TECHNICAL STAFF INSTRUCTIONS  
INDEX SHEET.

VOLUME TITLE AIRFRAME VOLUME NO 1  
SECTION TITLE VAMPIRE SECTION NO 2  
SUB SECT TITLE GENERAL ORDER SUB SECT NO A

VOLUME TITLE AIRFRAME.  
SECTION TITLE VAMPIRE.  
SUB SECT TITLE GENERAL ORDER.

FROM : Headquarters (Tech)  
Rhodesian Air Force

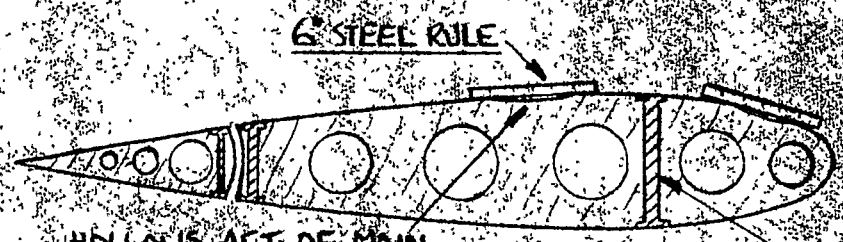
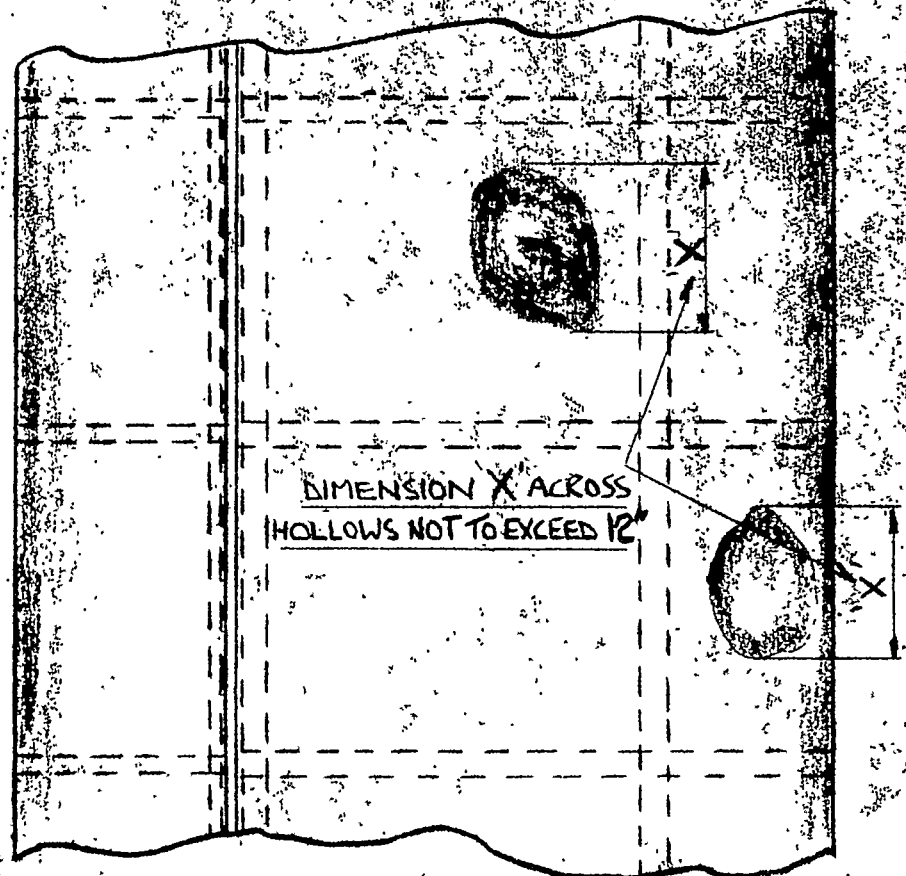
- (a) An examination of tailplane contours is to be carried out by means of a 6" steel rule and feeler gauges, as shown in the attached drawing. A tailplane is to be rejected if a hollow be found to extend more than 12" spanwise along the tailplane forward of the main spar on top or bottom surface. Any tailplane is also to be rejected if a hollow, deeper than 0.020" and extending more than 12" spanwise along it, be found aft of the main spar on either surface.

HOLLOW ART OF MAIN  
SPAR TO BE NO MORE THAN  
0.020\" DEEP. DEPTH TO BE  
DETERMINED BY FEELER GAUGES

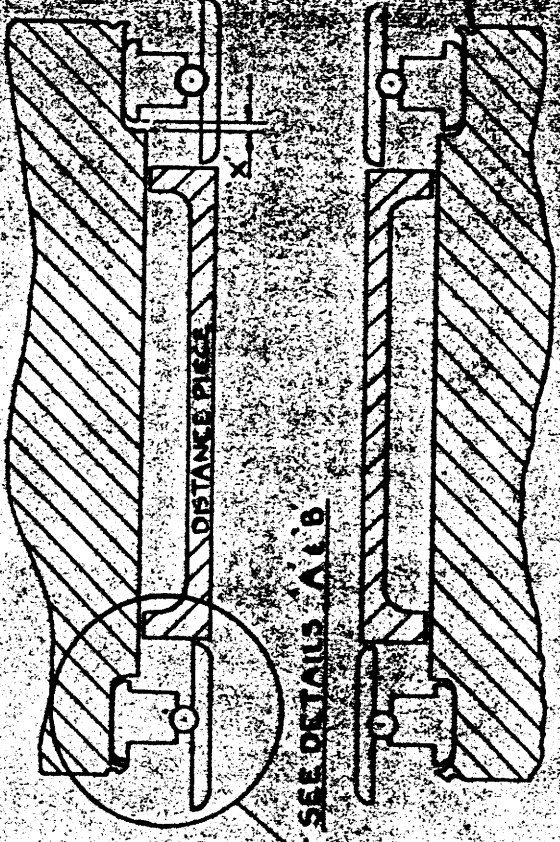
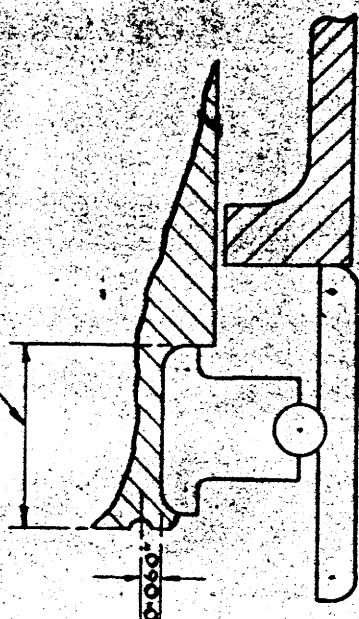
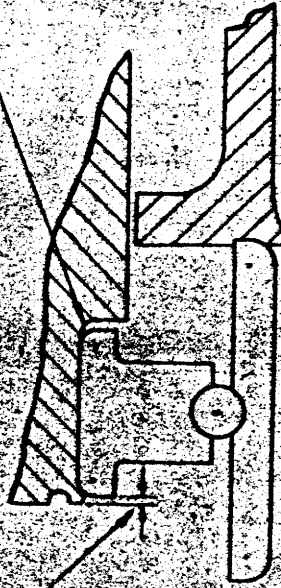
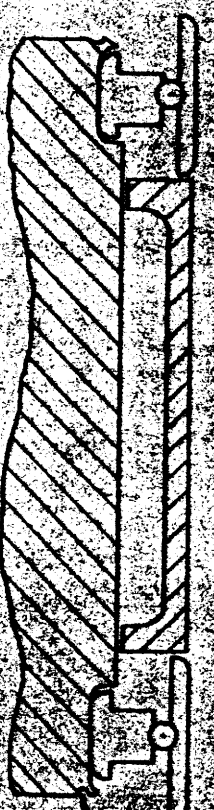
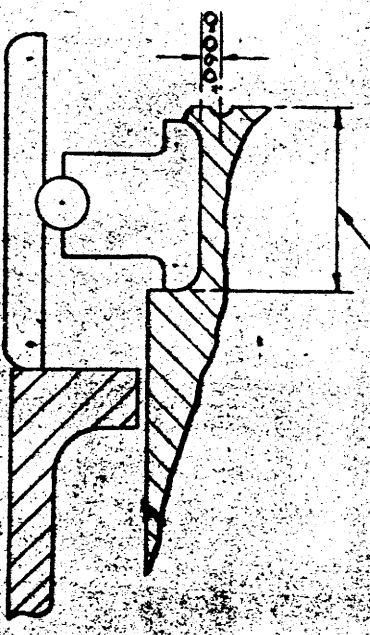
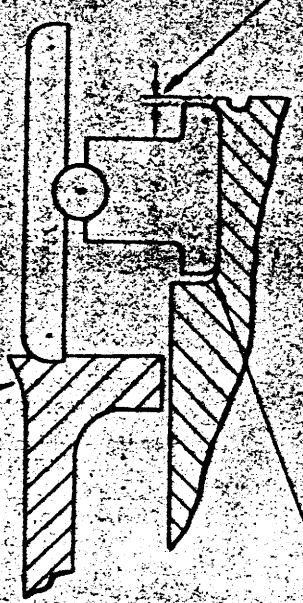
IF ABUTMENT RADIUS AT BOLT SHOULDER IS LARGER THAN THAT ON BALL RACE INNER TRACK IT WILL FORM AN EXPANSION CONE WHICH WILL CRACK THE BALL RACE ON TIGHTENING.

CAULKING ALLOWANCE BELOW MINIMUM PERMISSIBLE DUE TO BAD SEATING OF OUTER TRACK.

HOUSING RADIUS TOO GREAT CAUSING OUTER TRACK TO BE HELD OFF SHOULDER SO IMPAIRING EFFECTIVE SPACING OF BALL RACES.

IF PIVOT BOLT IS OVERTIGHTENED, BALL RACE INNER TRACK INDENTS DISTANCE PIECE CAUSING:-

- 1) BALL RACES TO BECOME END-LOADED WHEN DIM "X" (SEE ASSEMBLY D.W.G.) REDUCES TO NOTHING
- 2) POSSIBLE DIFFICULTY IN DISMANTLING DUE TO DISPLACED METAL BEARING

NOTE: POSITIVE AXIAL LOCATION OF THE LEVER ASSEMBLY DEPENDS ENTIRELY ON THE HOUSING FIT AND THE QUALITY OF CAULKING OF THE FIXED RACE. CAULKING OF THE FLOATING BALL RACE IS INTENDED ONLY TO PREVENT WITHDRAWAL OF THE BALL RACE ON DISMANTLING OF THE LEVER ASSEMBLY AND MUST NOT EXERT ANY PRESSURE ON THE OUTER TRACK.

- 1) A 1/32 RADIUS SPHERICAL ENDED PUNCH SHOULD BE USED.
- 2) DEPTH OF CAULKING TO BE APPROX .03"
- 3) CENTRE OF CAULKING TO BE APPROX .04" FROM EDGE OF HOUSING.
- 4) NUMBER OF CAULKS TO BE THE SAME AS REPORTED - SPACED BETWEEN THE OLD CAULKS.
- 5) ALLOWANCE FOR A FURTHER GAGE CHANGE WHEN NECESSARY.

**NOTE:** POSITIVE AXIAL LOCATION OF THE LEVER ASSEMBLY DEPENDS ENTIRELY ON THE HOUSING FIT AND THE QUALITY OF CAULKING OF THE FIXED RACE. CAULKING OF THE FLOATING BALL RACE IS INTENDED ONLY TO PREVENT WITHDRAWAL OF THE BALL RACE ON DISMANTLING OF THE LEVER ASSEMBLY AND MUST NOT EXERT ANY PRESSURE ON THE OUTER TRACK.

- 1) A  $\frac{1}{32}$  RADIUS SPHERICAL ENDED PUNCH SHOULD BE USED.
- 2) DEPTH OF CAULKING TO BE APPROX. .05"
- 3) CENTRE OF CAULKING TO BE APPROX. 10% FROM EDGE OF HOUSING
- 4) NUMBER OF CAULKS TO BE THE SAME AS BEFORE - SPACED ONE THIRD OF THE DISTANCE BETWEEN THE OLD CAULKS. THIS ALLOWS FOR A FURTHER RACE CHANGE WHEN NECESSARY.

CORRECT CLIPPING OF MAIN  
UNDERCARRIAGE HYDRAULIC HOSES

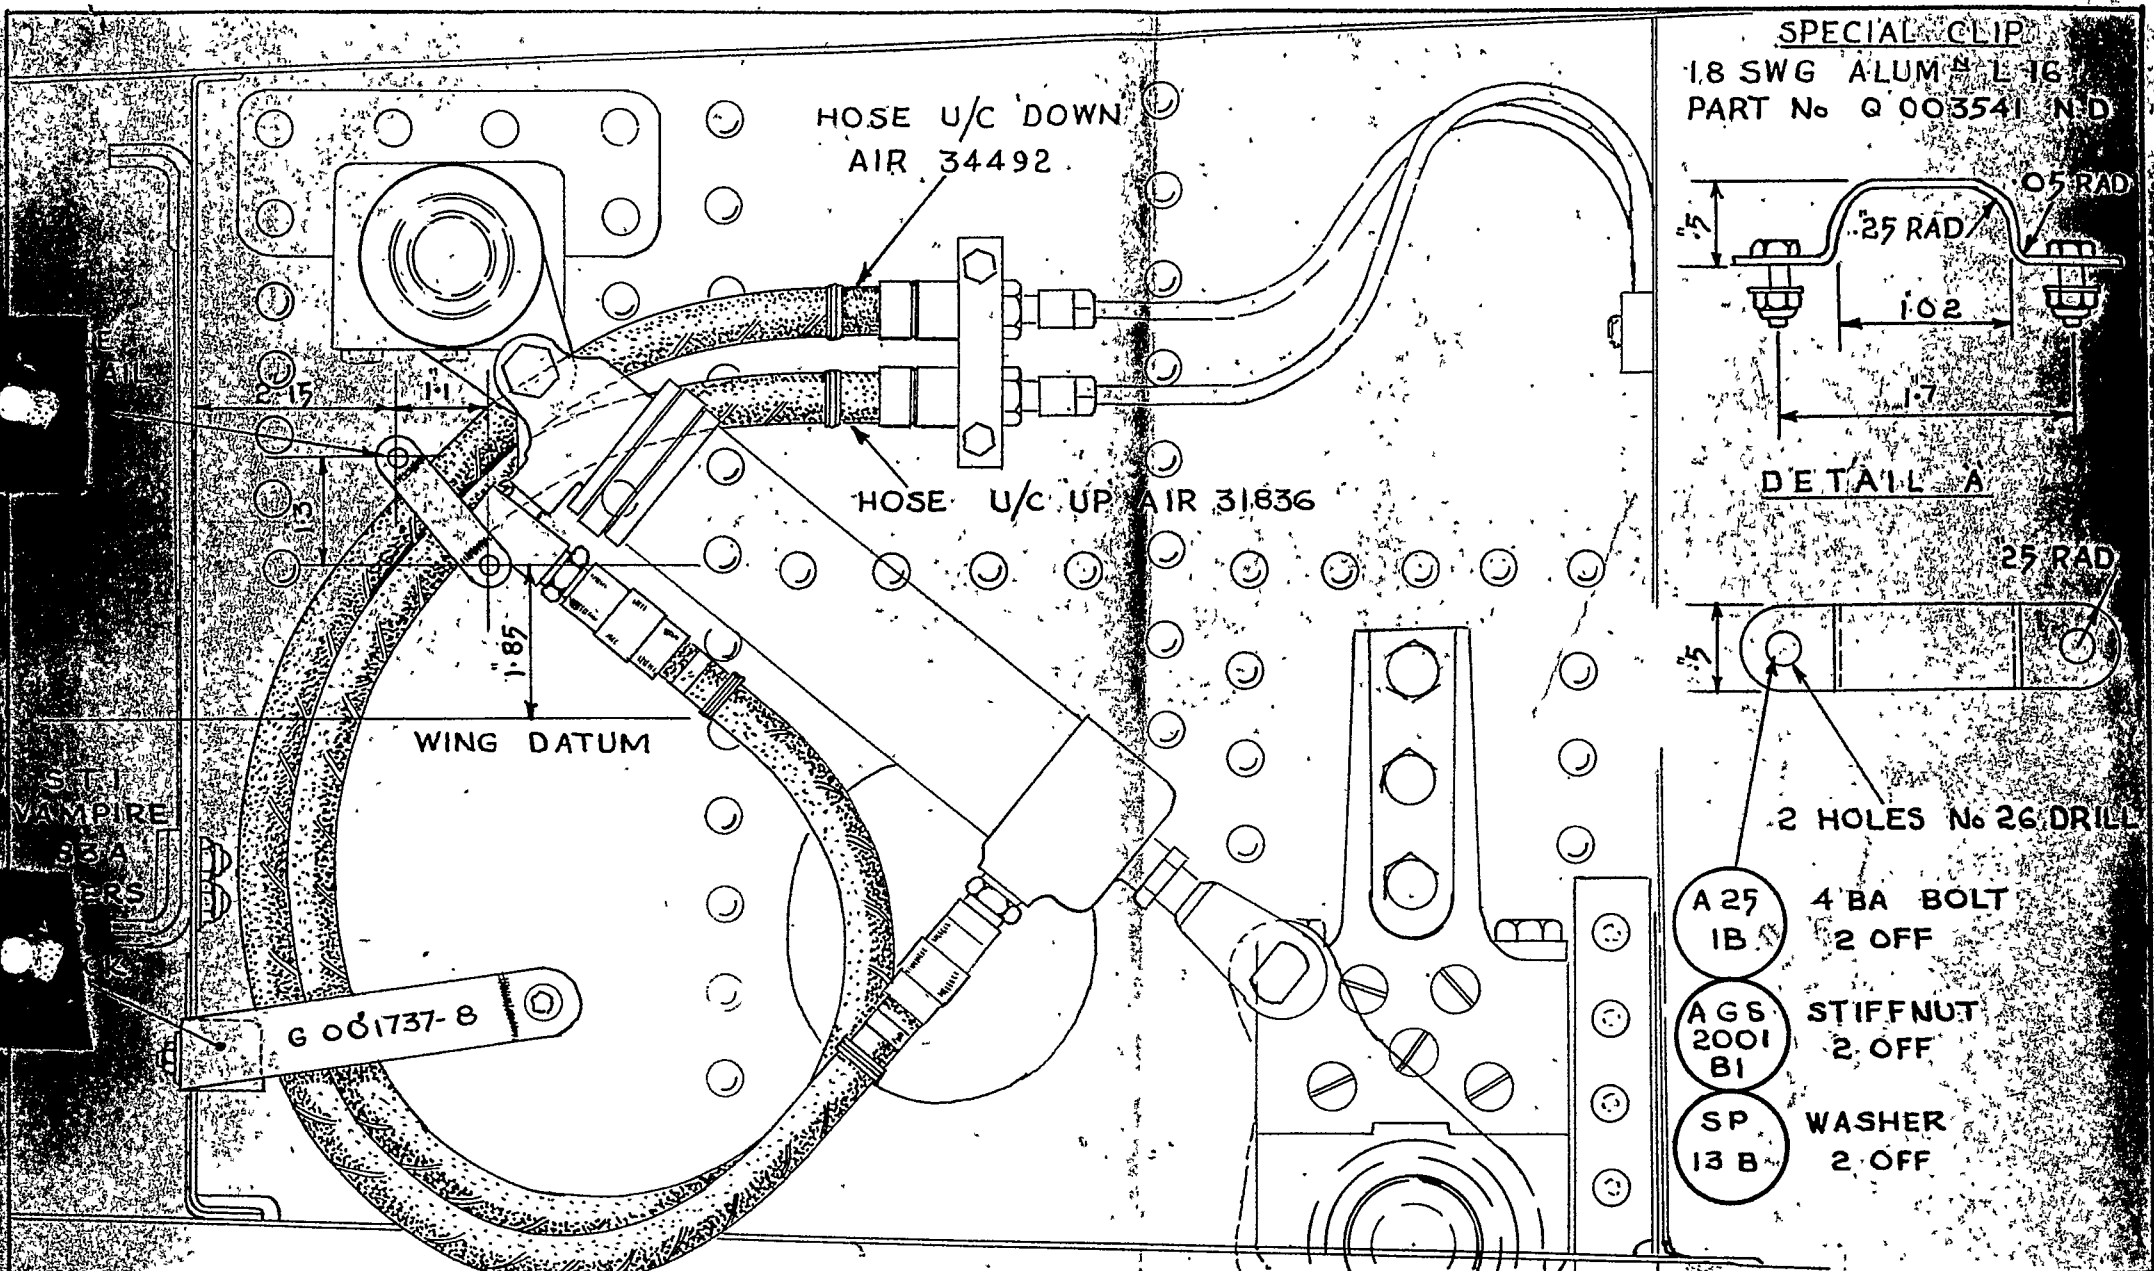
3. In future therefore whenever the hose concerned has been disturbed or the clips removed the arrangement detailed in the attached Drawing ROOG.48 is to be adhered to at re-installation or re-clipping of the hose.
